INITIAL FIRE SAFETY INSPECTION REPORT

Azim & Son (Pvt) Ltd Unit 2 (Extension)

RSC ID: 24322

Date: 7 February 2022

F-5

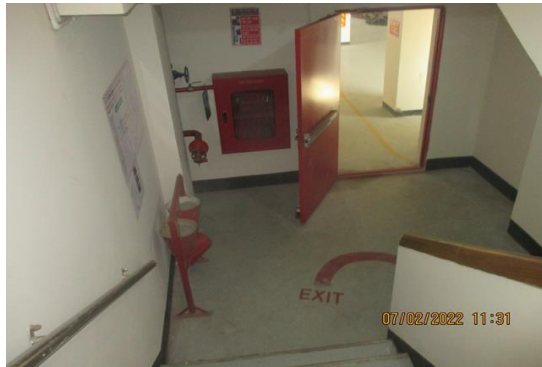
Building did not have stair designation signs and occupant load signs at required locations on all floors.

Building-5.

Provide stair designation signs and occupant load signs at required locations.

Within 1 Month
